**TRANSMITTAL OF RESPONSES TO THE U.S. ENVIRONMENTAL PROTECTION AGENCY
AND OHIO ENVIRONMENTAL PROTECTION AGENCY COMMENTS ON THE SOUTH PLUME
REMOVAL ACTION SYSTEM EVALUATION REPORT FOR JANUARY 1, 1997, THROUGH
JUNE 30, 1997.**

**RESPONSES TO U.S. EPA AND OEPA COMMENTS
ON THE DRAFT SOUTH PLUME REMOVAL ACTION
SYSTEM EVALUATION REPORT
FOR JANUARY 1-JUNE 30, 1997**

**FERNALD ENVIRONMENTAL MANAGEMENT PROJECT
FERNALD, OHIO**

Figure 1. Monthly average uranium concentrations and estimated daily recovery well pumping rates at RW-1(3924), RW-2 (3925), RW-3 (3926), and RW-4 (3927).

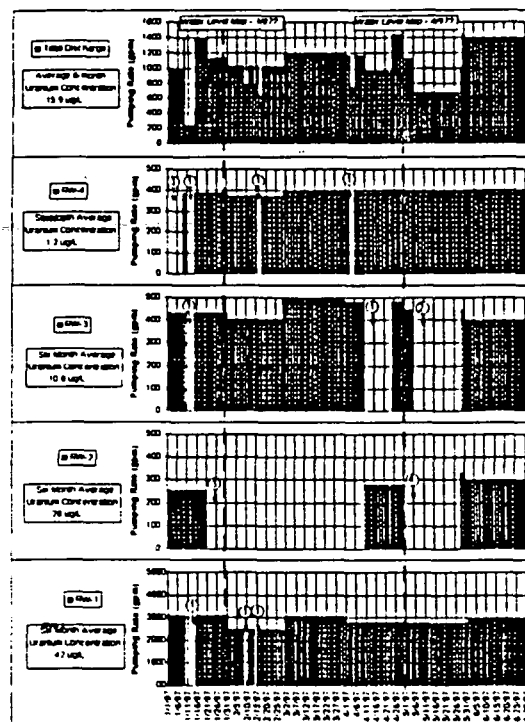
Comment: The operational summary sheets for the four extraction wells provide flow rates on a monthly only basis. To help assess system performance more accurately, average daily flows should be summarized graphically in this report.

Response: DOE acknowledges the comment. Daily pumping flow rates for the South Plume system are measured and recorded. These records are stored at the site and are available for inspection. However, DOE believes sufficient data is available in the report to evaluate the recovery system operation using the monthly average system pumping rates. As explained in the response to Comment #2, DOE will continue to strive to make the results which are reported as clear and concise as possible so that report preparation and review remain as efficient as possible.
